STATE OF HAWAII
 DEPARTMENT OF TRANSPORTATION
 HIGHWAYS DIVISION
TYPICAL SECTIONS & MISC. DETAILS
 HANA HWY. STORM DAMAGE REPAIRS
 Huelo Towards Nahaiku
 PROJ. NO. 360AB-01-92

STATE OF HAWAII
DEPARTMENT OF TRANSPORTATION
HIGHWAYS DIVISION
**REPLACEMENT OF WASHED-OUT
EXISTING CONCRETE APRON (OUTLET)
AT KAKIPI BRIDGE**
HANA HIGHWAY STORM DAMAGE REPAIR
Project No. 360AB-01-92
Scale: As Noted Date: July 1992

SHEET No. 51 OF 1 SHEETS
C.O. 5S-1

HORIZONTAL DRAIN PIPE DETAIL
 Not To Scale

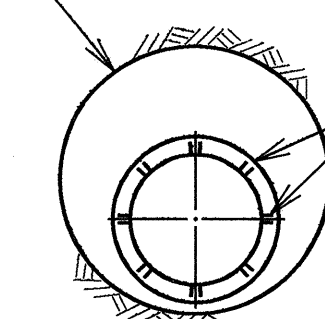
8/4/92 Added Lower Level Horizontal Drain Pipes

The Difference Between the Diameter of the Drilled Hole and Weep Shall Not Exceed 2".
